## Comparison report of Both the IC TI35AHGYM CD4066BM & IC TI55C8S3K CD4066BM

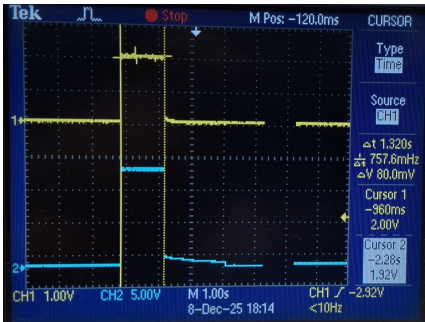
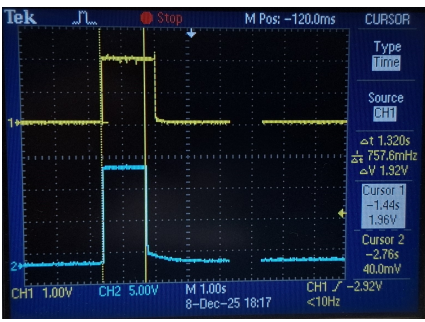
Sr. No.	Card Pulse 19 with IC TI35AHGYM CD4066BM at location U7	Card Pulse 19 with IC TI55C8S3K CD4066BM at location U7	Remarks
1.	Wave form of Control Signal at Pin no 13 and the wave form of output signal at pin No. 2 is same in case of IC TI35AHGYM CD4066BM at location U7 as shown in below image	Wave form of Control Signal at Pin no 13 and the wave form of output signal at pin No. 2 is not same in case of IC TI55C8S3K CD4066BM at location U7as shown in below image	<b>Not same</b>

**Conclusion:** - The time of control signal and the time of output signal is not same.
